CERTIFICATE OF APPROPRIATENESS

Applicant: Phuong Nguyen, agent, for Margaret Shaheen, owner

Property: Lot 20, Block 250, Houston Heights South Neighborhood Subdivision. The property includes an historic 1,064 sq ft, one-story wood single-family residence situated on a 6,600 square foot (50' x 132') interior lot.

Proposal: New **Garage** with second story Apartment

Side Setbacks (Addition and New Construction)

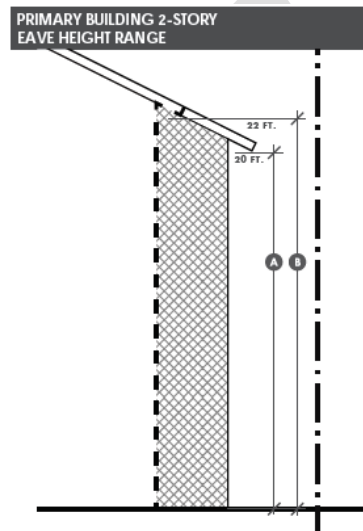
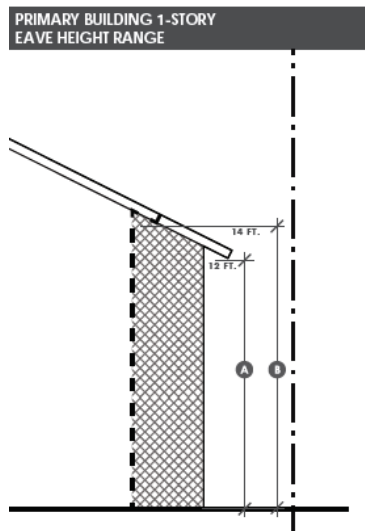
Proposed North side setback (1): 5 ft.

Proposed South side setback (2): 25 ft. 6 inches

Cumulative side setback: 30 ft. 6 inches

Eave Height (Addition and New Construction)

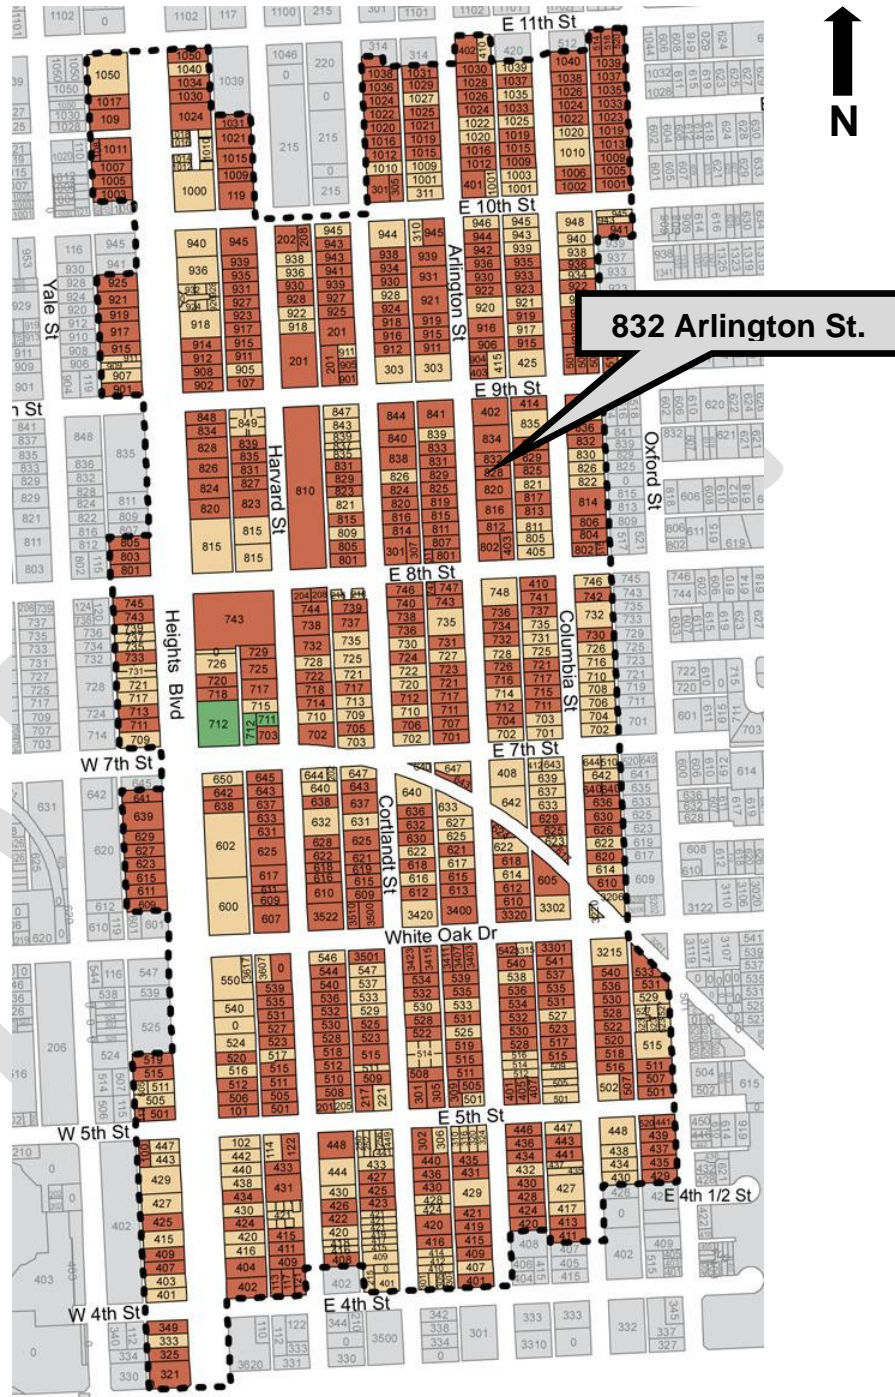
Heights Design Guidelines Section 5-16: Plate heights for additions should appear to be the same or lower than those of the existing house.

Proposed eave height: 19 ft. 4 ¼ inches
